Access Compliance Report

Public Rights-of-Way

Intersection ID: 7249	Main Street: HIDDEN_FOREST_DR	Cross Street: TOM_HUNTER_RD	Location: NE
ADA ID: 27144600AC01	Ramp Type: PerpDiag	Initial Pass/Fail: Fail	Overall Compliance: No
			Severity Score: 13.75

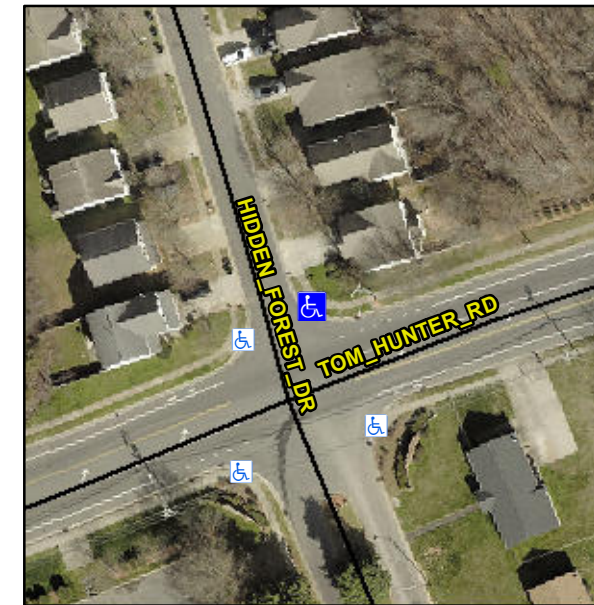
Not Found, R304.2.2, R304.5.3

Compliance	Description	Data	Compliance	Description	Data
N/A	Ramp Length (in)	42.5	No	Ramp Slope (%)	9.9
Yes	Ramp Width (in)	49.0	No	Ramp XSlope (%)	2.3
N/A	Flare Type LT	N/A	N/A	Flare Type RT	N/A
N/A	Flare Slope LT (%)	N/A	N/A	Flare Slope RT (%)	N/A
N/A	Flare Traversable LT?	N/A	N/A	Flare Traversable RT?	N/A
N/A	Landing Length (in)	N/A	N/A	DWS Provided?	N/A
N/A	Landing Width (in)	N/A	N/A	DWS Contrast?	N/A
N/A	Landing Slope (%)	N/A	N/A	DWS Length (in)	N/A
N/A	Landing X Slope (%)	N/A	N/A	DWS Full Width?	N/A
N/A	Landing Curb? (Y/N)	N/A	N/A	DWS Offset (in)	N/A
N/A	Shared Landing?	N/A			
N/A	Gutter Ponding?	N/A	N/A	Gutter Slope (%)	N/A
N/A	Gutter Lip Ht (in)	N/A	N/A	Gutter X Slope (%)	N/A
N/A	Painted X Walk1?	No	N/A	Painted X Walk2?	No
	X Walk 1 Direction	To W		X Walk 2 Direction	To S
N/A	X Walk 1 Width (in)	N/A	N/A	X Walk 2 Width (in)	N/A
	X Walk 1 Slope (%)	1.8		X Walk 2 Slope (%)	3.4
	X Walk 1 X Slope (%)	0.8		X Walk 2 X Slope (%)	3.8

Remove & Replace Curb Ramp With Two New Directional Ramps or Equivalent.
